**Re: Pacific Northern Gas (N.E.) Ltd.
Fort St. John/Dawson Creek and Tumbler Ridge Divisions
2020-2021 Revenue Requirements Application
Response to BCUC Information Request No. 2**

**Pacific Northern Gas (N.E.) Ltd.
Fort St. John / Dawson Creek Division and Tumbler Ridge Division
2020-2021 Revenue Requirements Application**

**INFORMATION REQUEST NO. 2
TO PACIFIC NORTHERN GAS (N.E.) LTD.**

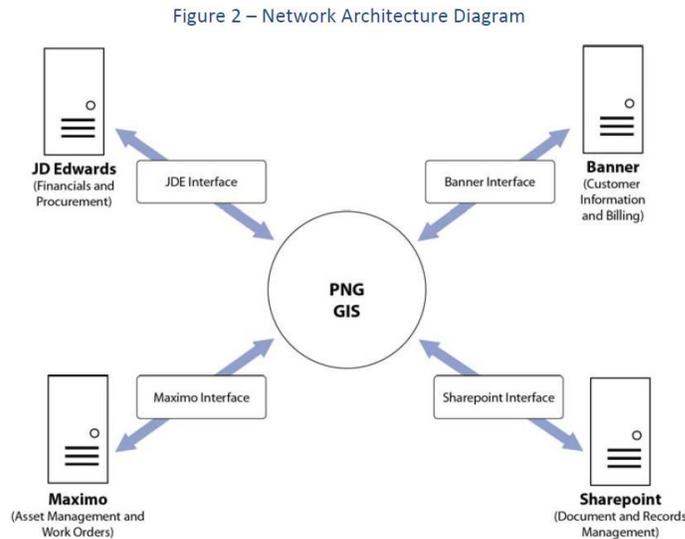
- 79.1 Please clarify whether “CMMS” and “Maximo” are references the same PNG system. If not, please discuss the differences between the two systems.

Response:
